STATE OF CONNECTICUT  
CONNECTICUT SITING COUNCIL

IN RE: :  
 :  
A PETITION OF SBA COMMUNICATIONS : PETITION NO. 1547  
CORPORATION FOR A DECLARATORY :  
RULING ON THE NEED TO OBTAIN A :  
SITING COUNCIL CERTIFICATE FOR THE :  
MODIFICATION OF AN EXISTING :  
TELECOMMUNICATIONS FACILITY AT :  
277 HUCKLEBERRY HILL ROAD, AVON, :  
CONNECTICUT : JANUARY 13, 2023

RESPONSES OF SBA COMMUNICATIONS CORPORATION  
TO CONNECTICUT SITING COUNCIL INTERROGATORIES

On December 8, 2022, the Connecticut Siting Council (“Council”) issued Interrogatories to SBA Communications Corporation (“SBA”), relating to Petition No. 1547. Below are SBA’s responses.

**Figure 1: Graph of General Population % MPE vs. Distance**

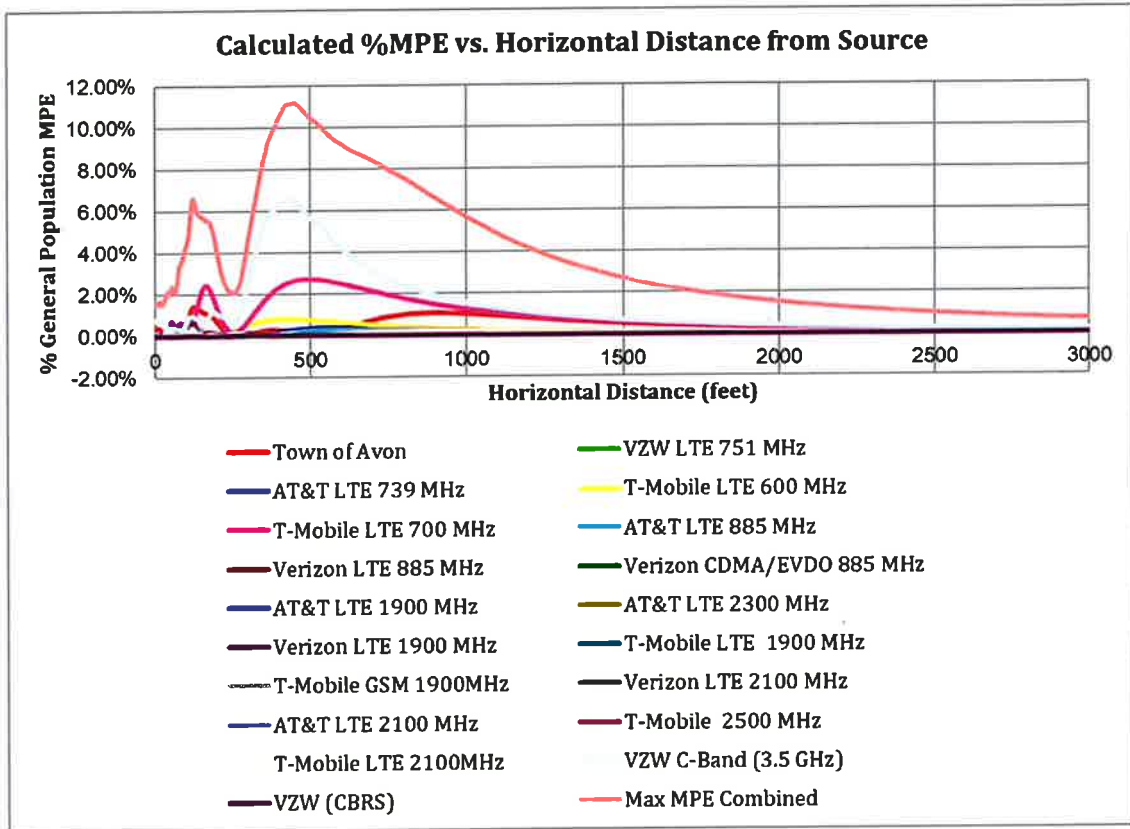
Provide a rigorous cumulative far-field radio frequency analysis for the replacement facility that accounts for Cellco's and the Town's proposed equipment and all other entities equipment on the tower, accounting for a 6-foot tall person at ground level and the actual antenna patterns for the facility with a cumulative %MPE at or below 100%. Identify the distance from the tower with the highest cumulative %MPE.

The highest percent of MPE (11.14% of the General Population limit) is calculated to occur at a horizontal distance of 450 feet from antennas. Please note that the percent of MPE calculations close to the site take into account off beam loss, which is determined from the vertical pattern of the antennas used. Therefore, RF power density levels may increase as the distance from the site increases. At distances of approximately 1500 feet and beyond, one would now be in the main beam of the antenna pattern and off beam loss is no longer considered. Beyond this point, RF levels become calculated solely on distance from the site and the percent of MPE decreases significantly as distance from the site increases.

Table 2 below lists percent of MPE values as well as the associated parameters that were included in the calculations. The highest percent of MPE value was calculated to occur at a horizontal distance of 450 feet from the site (reference Figure 1).
